SUBJECT: Forwards Potential Finding Repts 0008 & 0009 issued to
 Bechtel by SA Co. Repts not verified for validity & accuracy
 by original design organization.

Subject: Docket Nos. 50-361 and 50-362
San Onofre Nuclear Generating Station
Units 2 and 3

SONGS 2&3 SEISMIC DESIGN VERIFICATION

PFR NO. 2402-PFR-0009

Attachment #2

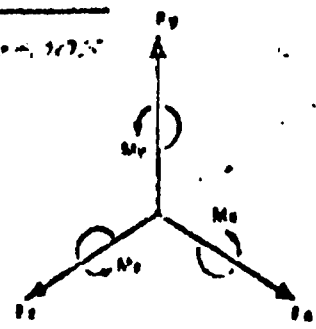
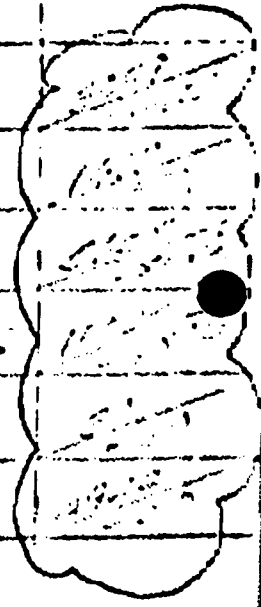
DESCRIPTION OF POTENTIAL FINDING: BPC supplied the initial design specification (Ref. 1) to the vendor (Brown-Minneapolis Tank). The vendor then supplied maximum allowable nozzle loads to BPC (Ref. 2, Attachment 1). These allowables are not traceable to the vendor's analysis (Ref. 3). BPC used these allowables as guidelines in performing the piping analysis (Ref. 2) and calculated actual design nozzle loads (Attachment 2). E. then supplied the vendor with an addendum to the design specification (Ref. 1, Attachment 1) specifying the design nozzle loads. This design specification and the piping analysis (Ref. 2) both BPC documents, are not consistent with one another. (see Attachment 2 and 3)

NATURE 7.11.71 DATE 8-22-70 CHECKED J. J. J. DATE 11-2-70
 SUBJECT 5811D12 JOB NO. 100713
 DET 5811D12 SHEET 5811D12 OF 5811D12

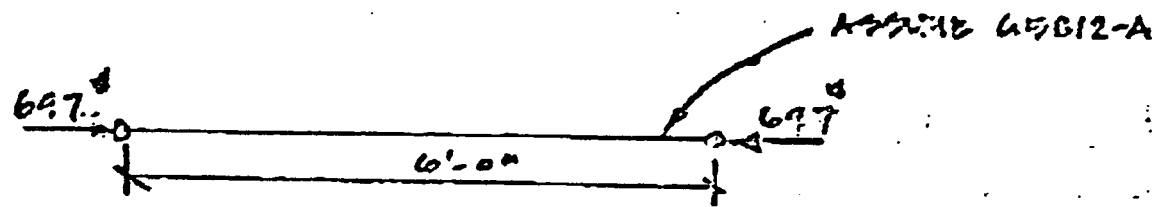
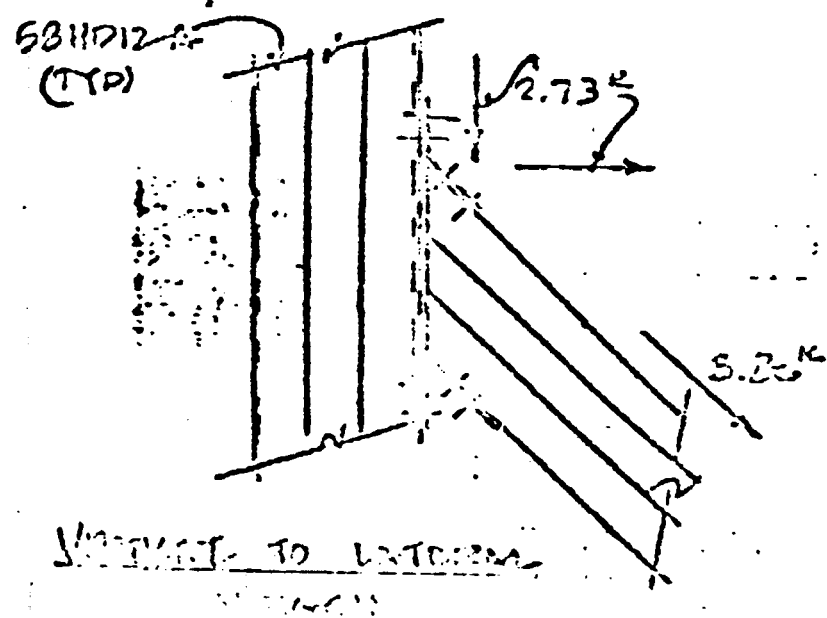
Axial load on lateral brace was calculated to be 3860 pounds (Sheet 361). Allowable
pull-out load on brace connection is only 3290 pounds (Sheet 364).
Therefore, the applied load, as calculated, exceeds the permissible load.
See Attachment 1.
